Portman Community Club

Accessibility Review

Transition Plan - (location/priority)

Photo 4: View of lobby single user toilet room. Replace the existing grab bar configuration with compliant side and rear wall grab bars. Replace the knob style hardware.

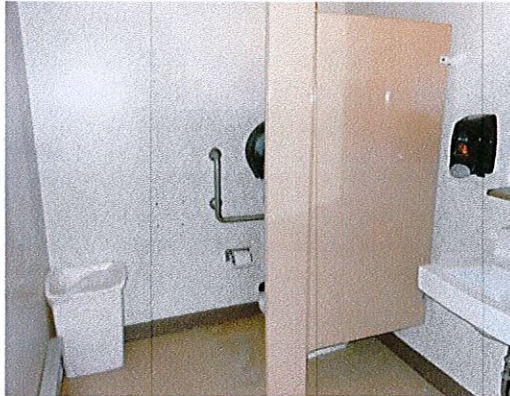
Location JQP # / Item #	Solution / Comments	Qty	Unit Cost	Total Cost	Priority	Estimated Compl. Date	Person Responsible	Actual Compl. Date	Actual Cost
Single User Toilet Room- Upper Level Lobby									
22-20D 16236	Provide door hardware that does not require grasping, pinching or twisting to operate, such as lever, push pull, etc. ICC / ANSI 404.2.6	1	\$250	\$250	3				
22B 16235	Install signage with appropriate raised and Braille lettering. MN 1341 1110.2	1	\$40	\$40	3				
22C4 16242	Alter swing of entry door so it does not intrude on the clear floor space of any fixture. ICC / ANSI 603.2.3	1	\$150	\$150	3				
22K6 (MN) 16240	Remove the existing grab bar configuration and replace with a compliant grab bar configuration. MN 1341 604.5.1 ANSI 604.5.2 <i>Photo 4.</i>	1	\$400	\$400	3				
22L (MN) 16241	Reposition the toilet paper dispenser so it is located below the horizontal grab bar. Operable parts should be located within an area 12" - 40" from the rear wall, and 18" minimum above the floor and 1 1/2" minimum below the horizontal grab bar. MN 1341 604.7 <i>Photo 4.</i>	1	\$50	\$50	3

22Q 16237	Insulate or otherwise protect exposed pipes at lavatory. ICC / ANSI 606.6 <i>Photo 4.</i>	1	\$50	\$50	3				
22R 16238	Replace the existing lavatory faucet with hardware that does not require grasping, pinching or twisting to operate. ICC / ANSI 309.4, 606.4 <i>Photo 4.</i>	1	\$450	\$450	3				
22V 16239	Install a full-height mirror or provide a mirror where the bottom of the reflective surface is no higher than 40" above the floor. MN 1341 603.3 <i>Currently at 47".</i>	1	\$300	\$300	3				
				<i>Location Subtotal:</i>					\$1,690
Storage- Lower Level									
20D 16263	Provide door hardware that does not require grasping, pinching or twisting to operate, such as lever. ICC / ANSI 404.2.6	1	\$250	\$250	3
